Our Ref: 1/2024/PLP

### **OUTCOMES OF PRELIMINARY ASSESSMENT – WEST GABLES PRECINCT (1/2024/PLP)**

- Fontana Drive, Terry Road and Old Pitt Town Road intersection

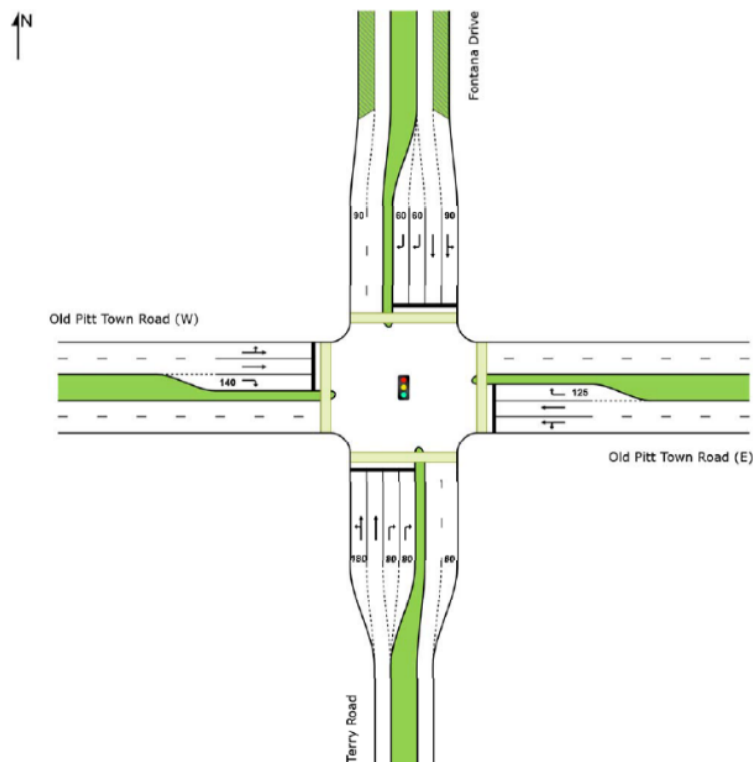
The Fontana Drive, Terry Road and Old Pitt Town Road intersection is to be upgraded to signals. The warrant study has been approved by TfNSW and the updated intersection layout is provided below:

This intersection is currently partially funded through a combination of contributions from the existing Box Hill North VPA and Box Hill Contributions Plan (CP15). Noting that Old Pitt Town Road is a flood evacuation route, that future residents of West Gables will need to utilise to safely evacuate in the event of a flood, it is appropriate for development that would be permitted through this planning proposal to also contribute to the upgrade to signals. Land acquisition costs are already funded through CP15, therefore only contributions toward capital works would be needed. It is estimated that approximately 10% of the capital works should be apportioned to the development facilitated by this planning proposal.

- Valetta Drive, Mt Carmel Road and Old Pitt Town Road intersection

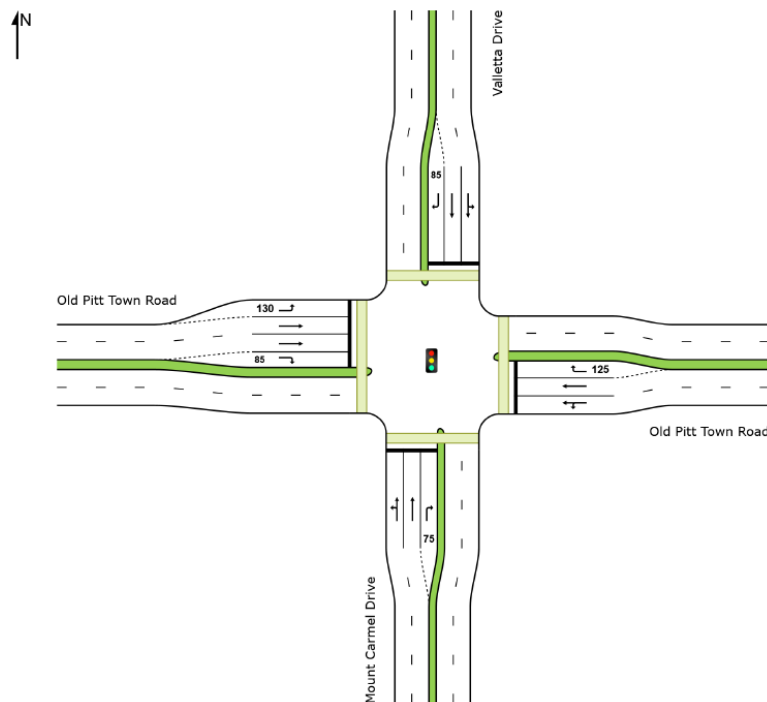
This intersection is to be upgraded to signals. The traffic report provided with the planning proposal indicates additional turn lanes and slip lanes beyond the current intersection design are required. This will require additional lanes, service relocations and land on the north side of Old Pitt Town Road. Noting that the proposal generates the need for the redesign of this intersection and Old Pitt

Town Road is the flood evacuation route, it is appropriate that contribution be made toward this intersection upgrade. The updated intersection layout is shown below:
